AQUIND Interconnector application for a Development Consent Order for the 'AQUIND Interconnector' between Great Britain and France (PINS reference: EN020022)

Mr. Geoffrey Carpenter & Mr. Peter Carpenter (ID: 20025030) in relation to Little Denmead Farm

Post Hearing Note in relation to Compulsory Acquisition Hearing 3: the Introduction of a new Description of Development comprised of 'extension' of the existing Lovedean Sub-station

Submitted in relation to Deadline 8 of the Examination Timetable

Plate 3.4 - Proposed Eastern and Western connection bays at Lovedeane Substation.

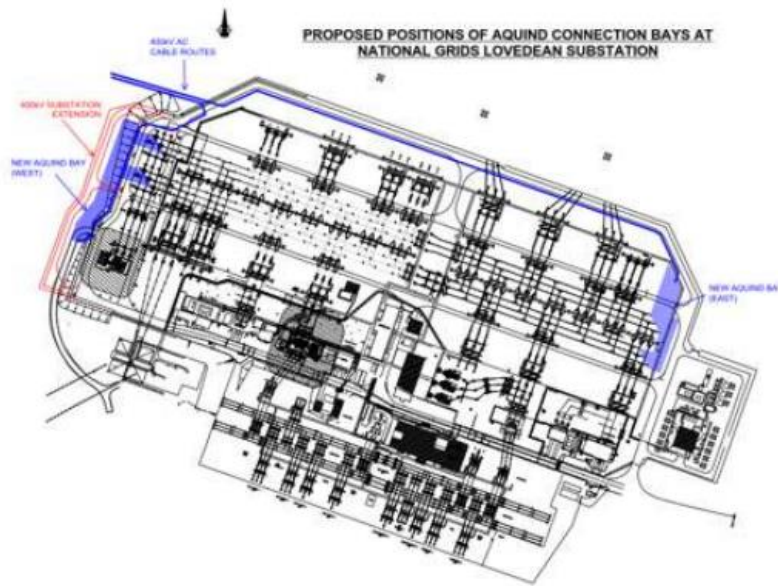
37. Plate 3.4 of the environmental statement "description of development" helpfully shows (not an "extension" but) the "*connection bays*" and is replicated below for ease of reference ("**the Connection Bays**"):

38. By this it can be seen that the western extension of the Sub-station is not itself coloured and it can be seen and established that the red area is not as extensive as the red line area to which the NG Extension Permission related (if lapsed) and relates (if not lapsed) (which we have previously provided to the Examination in detail) which is shown here:

39. Comparison of Plate 3.4 and the above shows Plate 3.4 as extended westwards and the coloured elements alone forming part of the EIA Development of the Application. The Letter then continues to:

40. Therefore, it is reasonable to conclude that the starting point was that the audit focussed on the *Connection Bays* in some way themselves being characterised as ‘the extension works’ to the existing Lovedean substation referred to and not the wider works envisaged by the NG Extension Permission.
